Permit Application Review Report
Date: 4/22/2026

Project Name: Crosstown Shopping Center Street Reconstruction

Project PAN: P-23-021

Recommendation: Approve with 4 Conditions and 3 Stipulations

Figure 2: Soils and Erosion Control

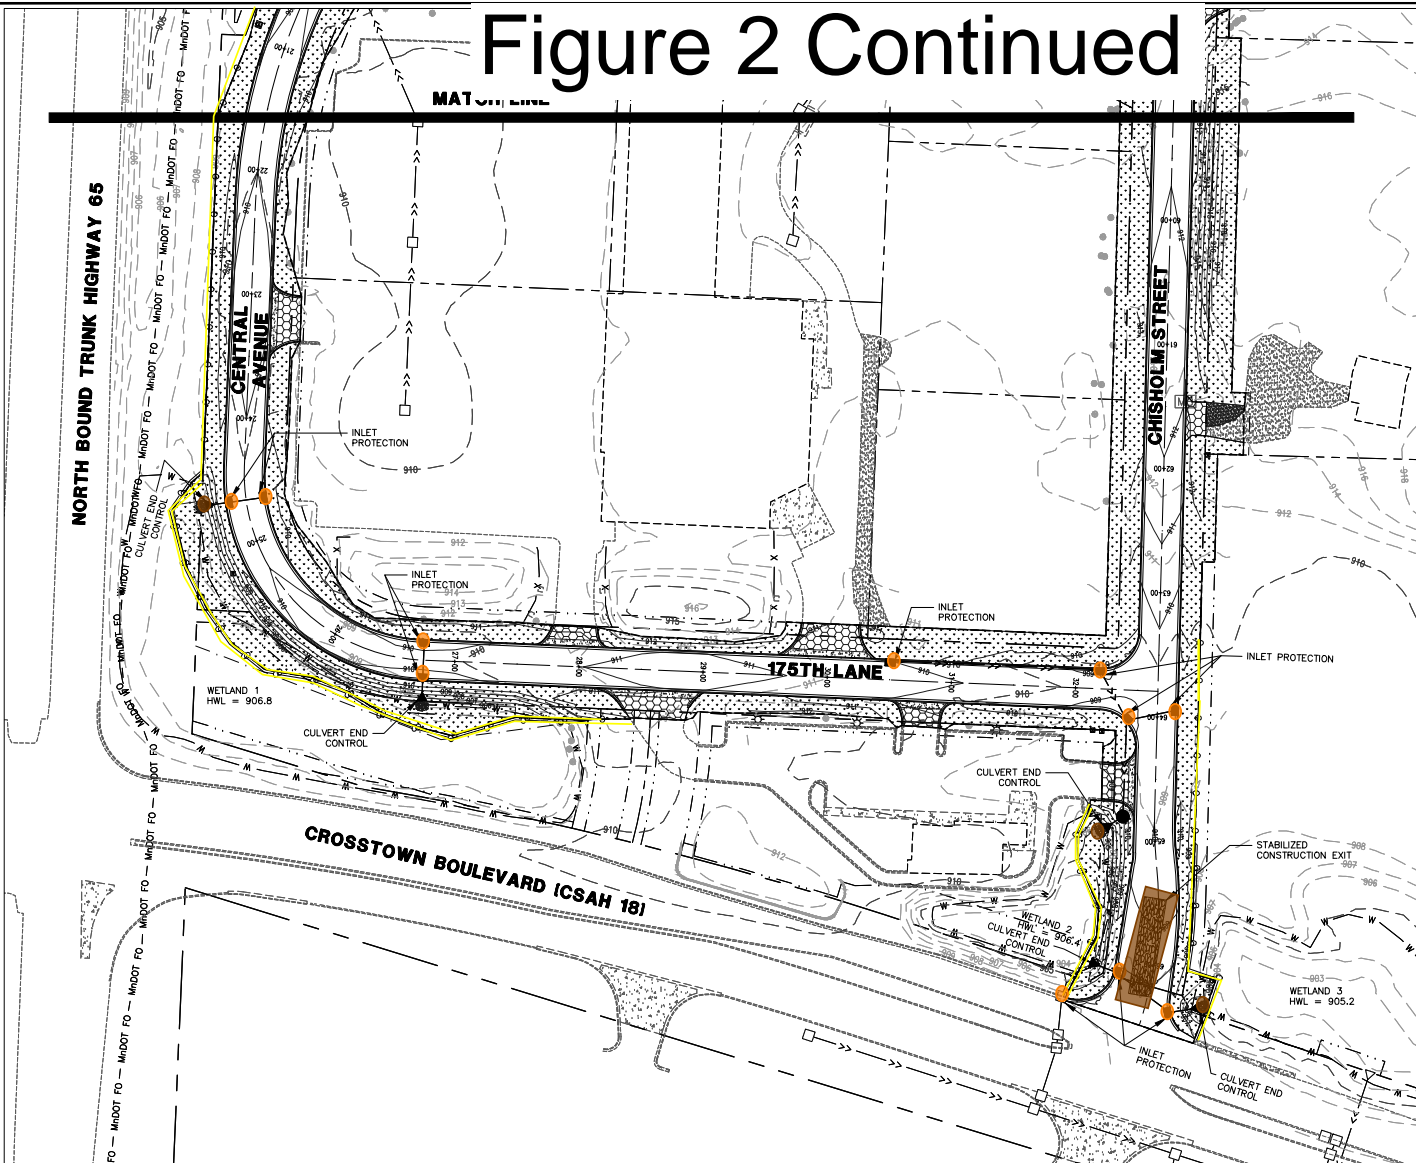
The proposed project drains to both the URRWMO and County Ditch 58. The soils affected by the project include Zimmerman, Isanti and Lino and have a soil erodibility factor of 0.15 or greater. Disturbed areas are proposed to be stabilized within 24 hours, as required. The proposed erosion and sediment control plan includes perimeter control, stabilized construction entrance, riprap, inlet protection and street sweeping. The erosion control plan meets District Requirements. The site does require an NPDES permit.
